ENGINE - LP COMPRESSOR - RE-DESIGN THE LPC BLEED VALVE ACTUATING ROD - CATEGORY CODE 6
- MOD.ENG-72-0250

V2500-ENG-72-0250

SERVICE BULLETIN

Replacement of LPC Bleed Valve Actuating Rod
Fig.1 (Sheet 1 of 2)

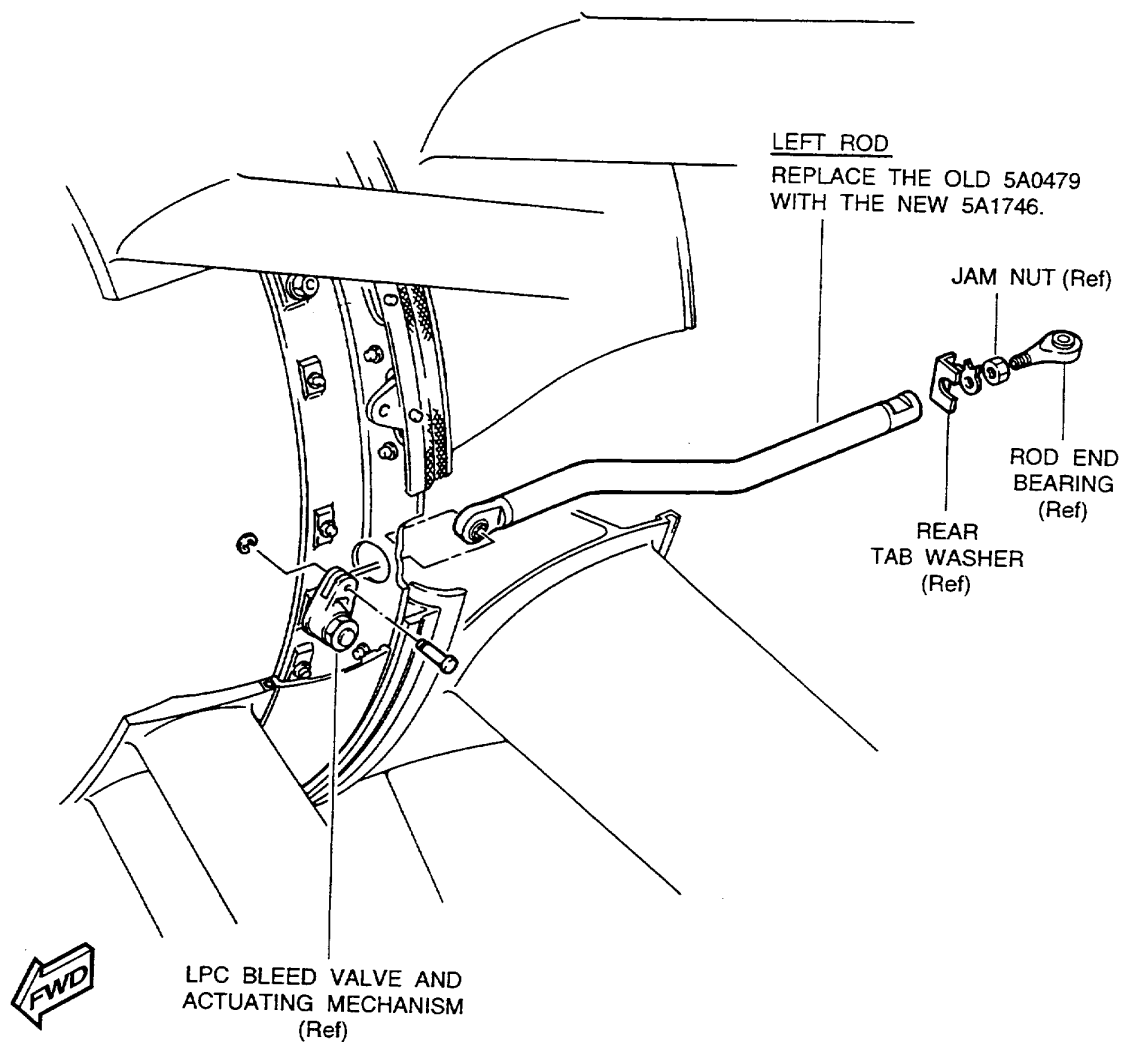
There is insufficient clearance between the LPC Bleed Valve Actuating Rod and the Fan Frame Wall.

To re-design the LPC Bleed Valve Actuating Rod to keep sufficient clearance between the LPC Bleed Valve Actuating Rod and the Fan Frame Wall.

- (1) This Service Bulletin introduces a new LPC Bleed Valve Actuating Rod.
- (2) Existing Rod can not be reworked.

- (1) Install the new 5A1746, Left Rod and the new 5A1747, Right Rod into the Left and Right LPC Bleed Valve Actuating Rod Mechanism by the approved procedures of Reference (2), Chapter/Section 72-32-00, Assembly-08.
(Refer to Figure 1, Sheet 1 and 2)
